**REPORT ON THE ASSESSMENT OF
DEVELOPMENT APPLICATION NO DA-308-12-2004-i
PURSUANT TO SECTION 80 OF THE ENVIRONMENTAL PLANNING AND
ASSESSMENT ACT, 1979**

**PROPOSAL BY MACQUARIE GOODMAN MANAGEMENT LTD TO
CONSTRUCT A DISTRIBUTION CENTRE FOR COCA COLA AMATIL TO
OPERATE AND TO SUBDIVIDE LAND IN THE EASTERN CREEK SEPP 59
AREA, PART LOTS 11, 13 AND 14 DP 1072146 IN THE BLACKTOWN
LOCAL GOVERNMENT AREA**

June 2005

Figure 4: The Applicant's revised proposed building façade.

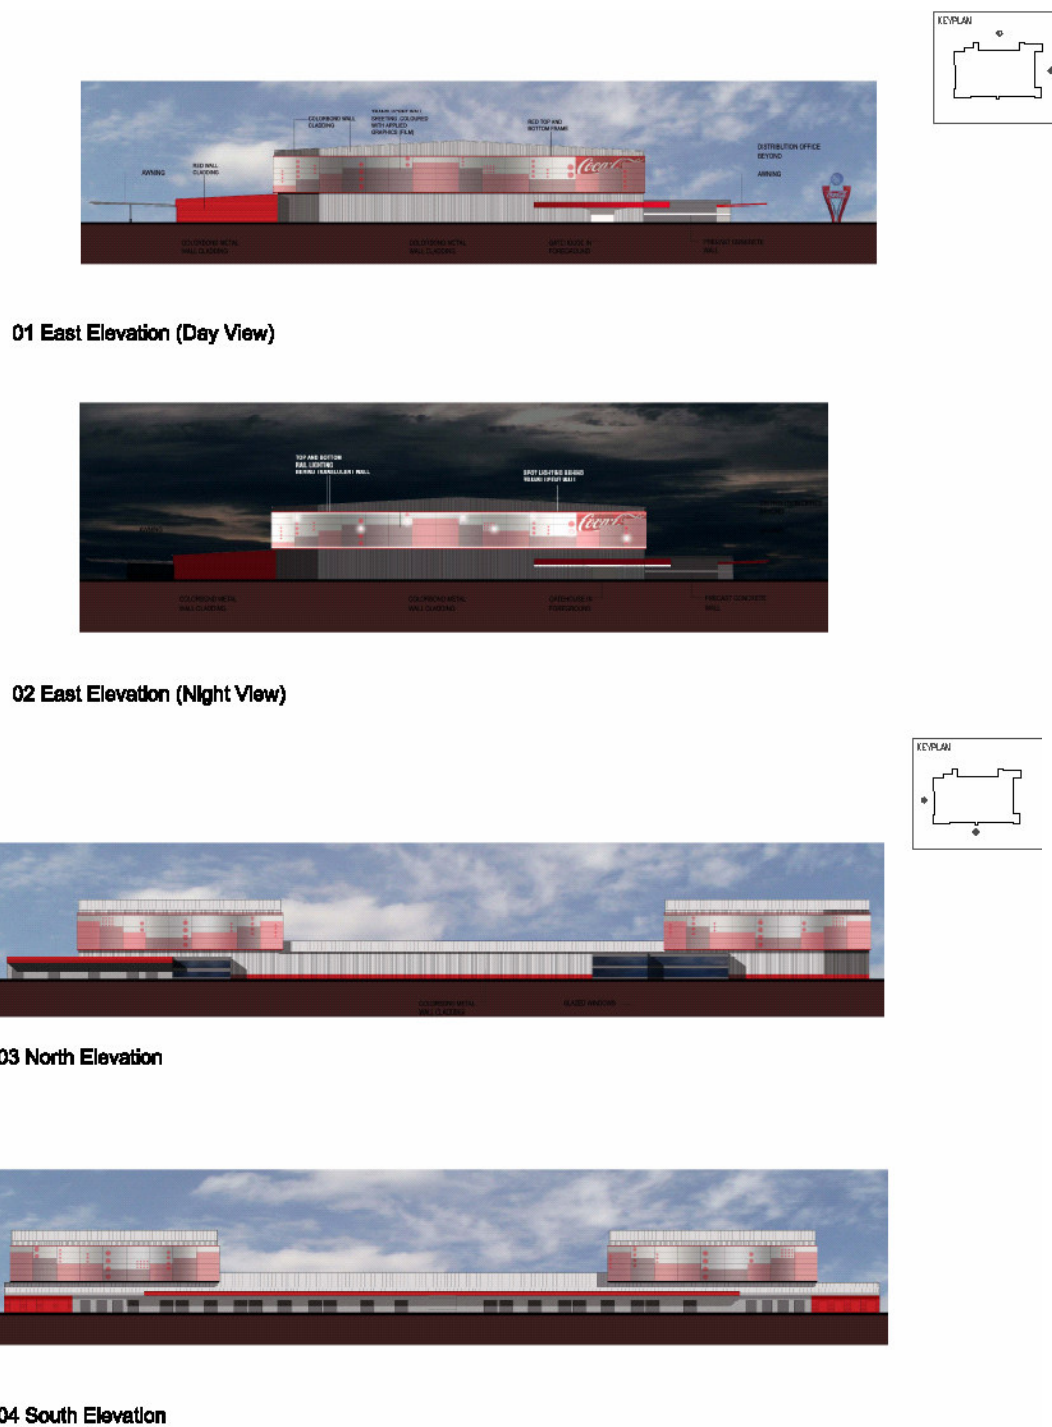
Blacktown Council raised concerns in relation to the urban design, visual amenity and landscaping issues. Council raises concern about the colour scheme proposed by the Applicant, in particular the amount of red on the façade and the elevations, and the signage on the building that is considered general advertising and not business identification signage. Council also raises concern regarding the proposed site coverage, and the landscaping plan.

The Department generally supports the revised building design except for three issues. Firstly, the Department still does not consider it appropriate to use the high bays for any kind of direct advertising. The Department acknowledges that the Applicant has generally removed advertising from the high bays, except for a small cut-off Coca-Coal sign. The Department does not consider this sign as being necessary for building identification, as it appears to be intended to be viewed from a distance rather than from near observers. Secondly, the Department does not consider the pylon signage to be appropriate, due its height and scale. Thirdly, the Department notes that the primary purpose of the lantern box façade was to draw attention away from the metal cladding of the building structure. The Department therefore considers that the top lip of the lantern should be raised to ensure that the peaked metal clad roofing of the building is not observed from a distance as being above the lantern box. The Department recommends that the Applicant be required to obtain approval from the Director-General for the final detailed design prior to the commencement of building works, to ensure that these issues have been satisfactorily addressed.

In response to the Department's concerns, the Applicant proposed to remove the bulk of the signage and advertising from the elevated sections of the building, and creating a continuous light band around each of the high bays to shift the primary focus away from the scale of the steel cladding, see Figure 4. When seen from a distance, while still retaining the focus on the high bays, changes the appearance from being of two large metal sheds, to two floating translucent boxes that vary in colour and shade throughout the day and night. Particularly at night, where they are seen as two soft glowing lanterns within the vast landscape.
